Dear Reviewers

Reviewer #2: The manuscript entitled "Towards a Pixel TPC part I: construction and test of a 32 chip GridPix detector" reports on the construction and first test beam results of a Time Projection Chamber (TPC) read out by 4 x 8 GridPix chips, 256 x 256 pixels each, and a maximum drift length of 40mm. Building upon previous detectors employing a single or four GridPix chips, the results presented in the manuscript are significantly new and important, a priori justifying publication in Nucl. Instr. Meth. Before doing so, however, a number of issues, related to the presentation and the analysis should be addressed.

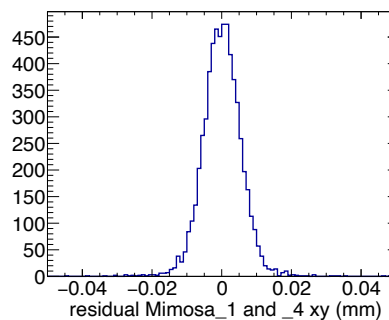
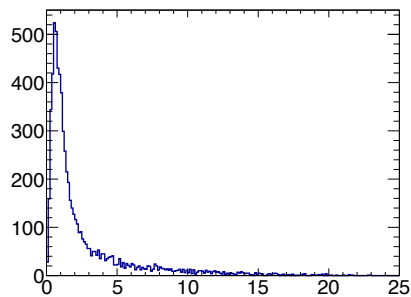
- Line 156: why is the track chi2 cut so large? What is the distribution of the reduced chi2?

Answer: The value was chosen to keep a high tracking and silicon plane "on track" efficiency.

Plots for the chi2/ndof and the residuals in the M1 plane
